Re: NRC Request for Additional Information Dated March 14, 2014 - Crow Butte and Smith Ranch/ Highland Public Dose Compliance

## Attachment A

### Cameco Response to Draft Crow Butte License Conditions 11.11 A through C

### **MILDOS-Area Modelling and Validation of Emissions and Public Dose for the Crow Butte Facility**

Figure 2.4-1 Iso-curves of Predicted Annual Dose in mrem/year

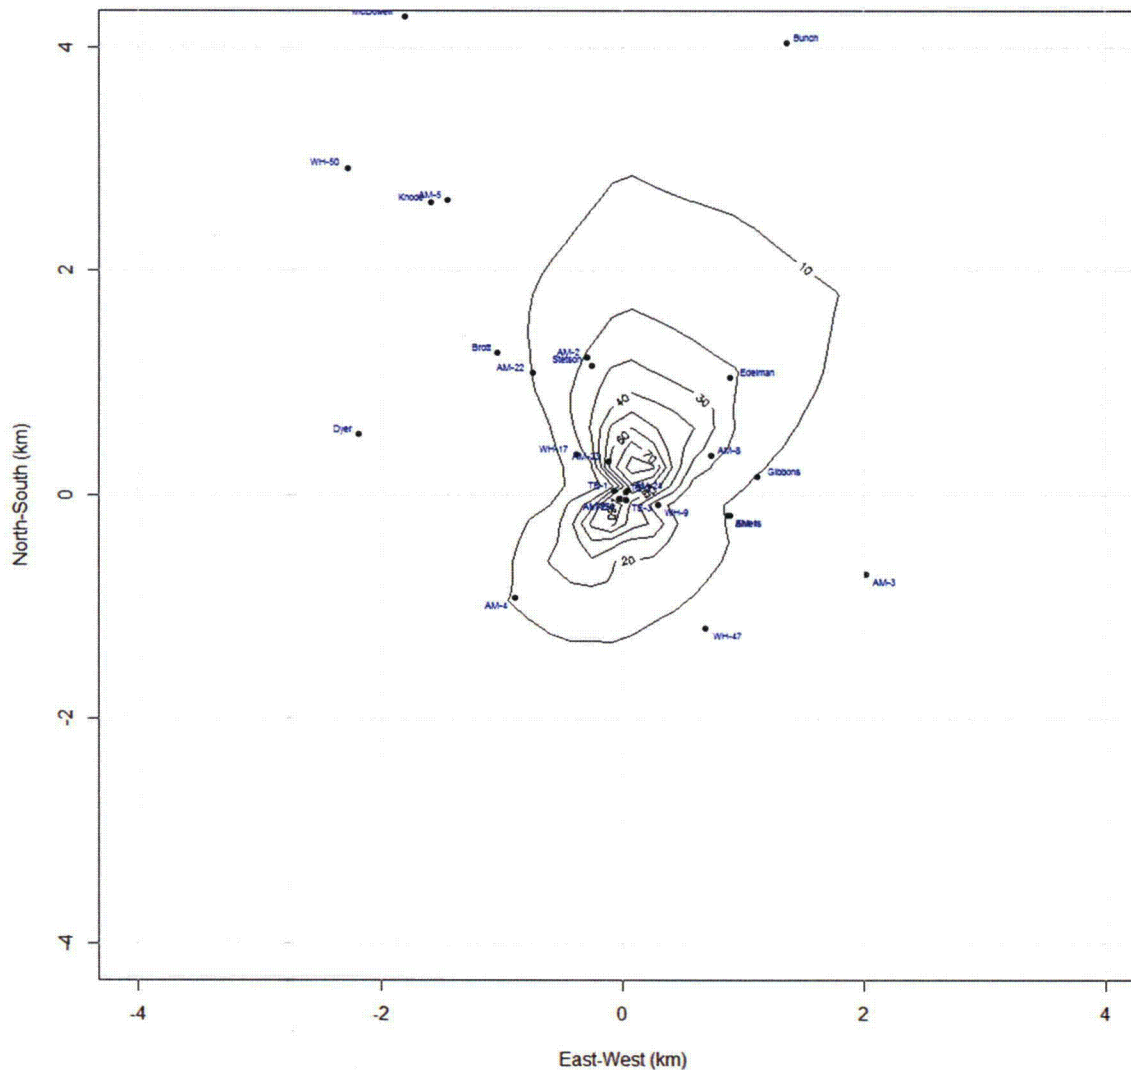
The Addendum to this document contains a description of MILDOS-Area modelling performed to determine the member of the public likely to receive the maximum dose. In summary, the assessment of receptor doses considered both actual and potential receptors. The actual receptors included local residents, including the nearest resident located approximately 1000 m north-east of the main plant. Potential receptors were members of the public who may be at or near the site for greater than 50 hours per year and included a delivery person and ranchers performing haying or cattle related activities. For the potential receptors an estimate was made of the hours spent at or near the site.

Based on the outputs of this assessment, the member of the public likely to receive the maximum dose is the resident located approximately 1000m to the north-east of the plant.
